**ENGINEERING BULLETIN No. 23**

**November 6, 1944**

**Subject:** Inspection and alteration of tail bulkhead and fin spar for clearance of elevator horn

**Aircraft Affected:** All Luscombe Model 8 series aircraft. (8, 8A, 8B, 8C, and 8D) serials 801 and up.

VIEW LOOKING FORWARD

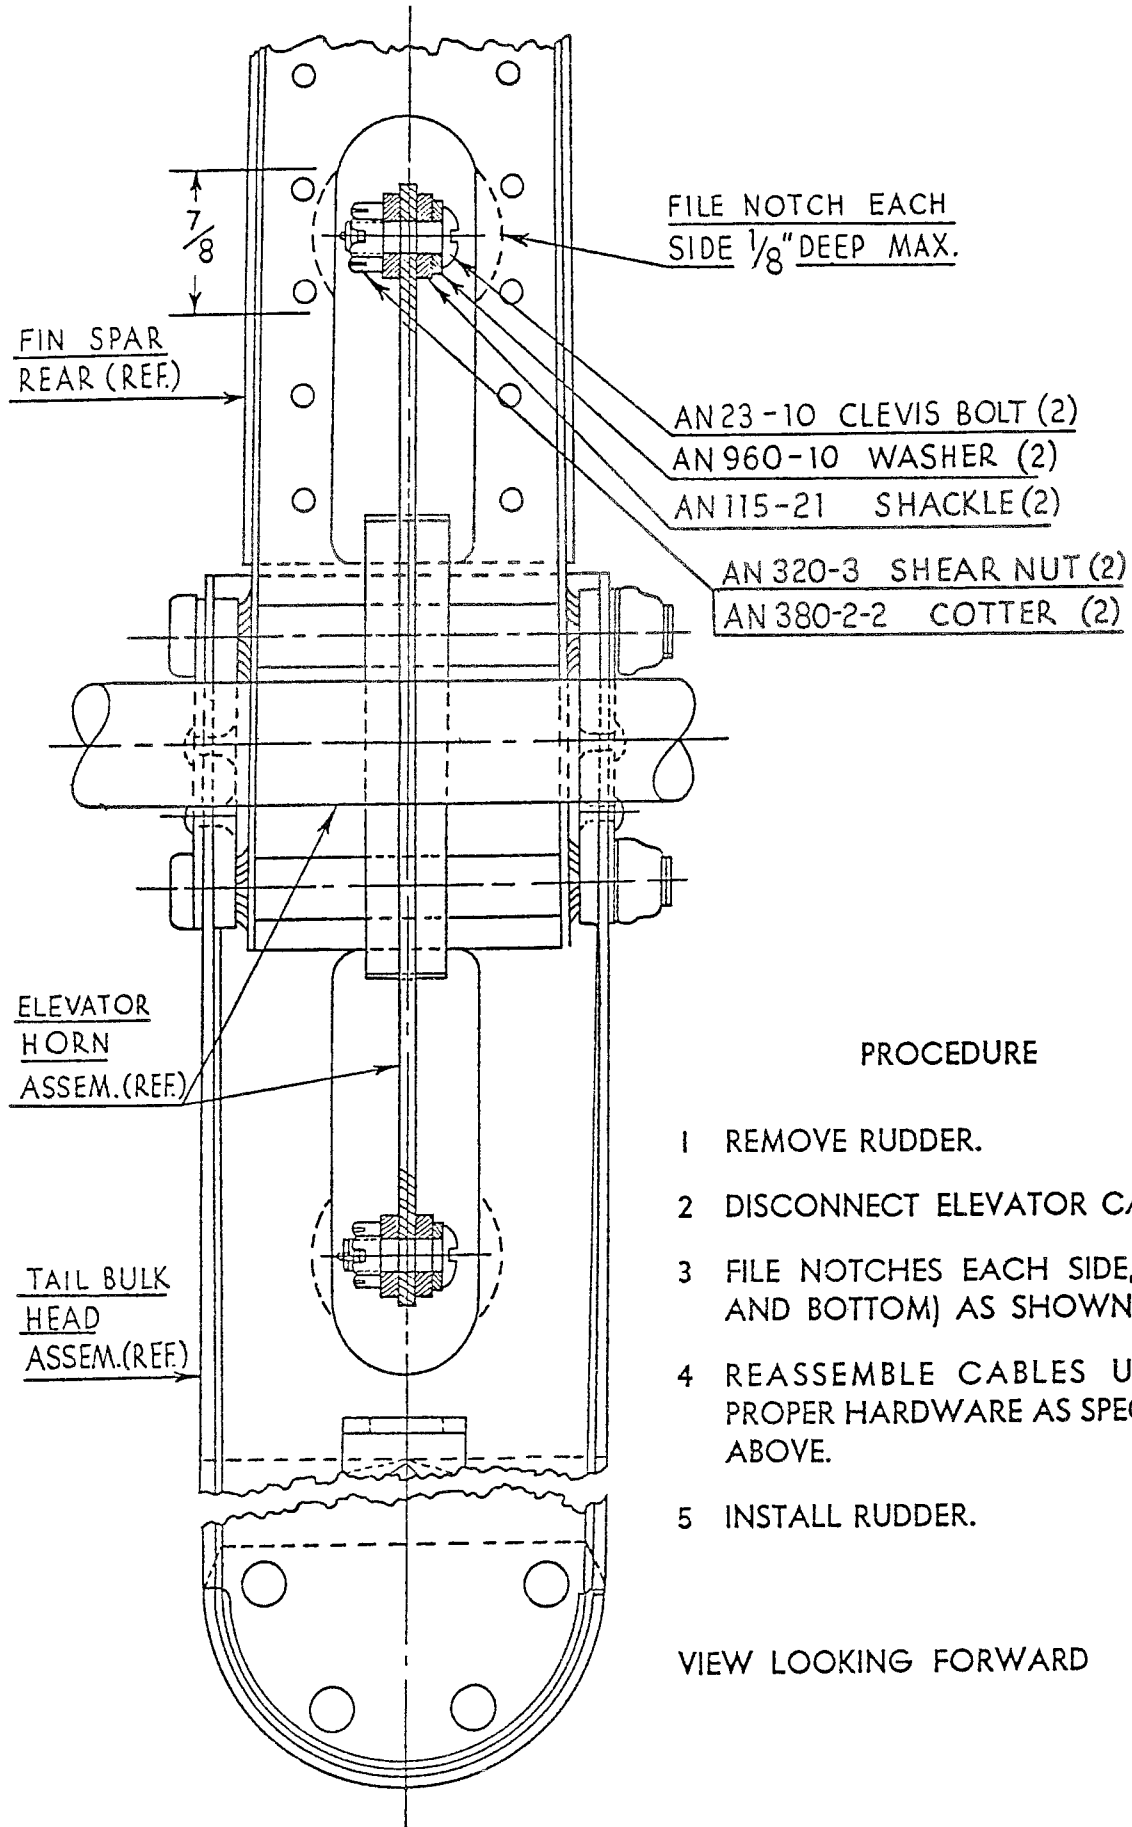
Reports have reached us recently concerning the lack of clearance between the bolts in the elevator cable attachment to the elevator horn and the openings in the fuselage tail bulkhead and rear fin spar, when standard AN hex head bolts are used. Occasionally mechanics in the field have changed elevator cables and replaced the original clevis head bolt with a hex head bolt. Any wear in the elevator hinges which may allow the elevator to shift its position may then cause the elevator horn to jamb the controls.

You are therefore urged to inspect this point immediately to determine that the proper bolt is used as shown in sketch and that there is ample clearance for the elevator horn travel. In order to obtain ample clearance it is suggested that notches be filed in the bulkhead and fin spar not more than  $\frac{1}{8}$  inch deep, as shown in sketch.

- 1 REMOVE RUDDER.
- 2 DISCONNECT ELEVATOR CABLES.
- 3 FILE NOTCHES EACH SIDE, (TOP AND BOTTOM) AS SHOWN.
- 4 REASSEMBLE CABLES USING PROPER HARDWARE AS SPECIFIED ABOVE.
- 5 INSTALL RUDDER.
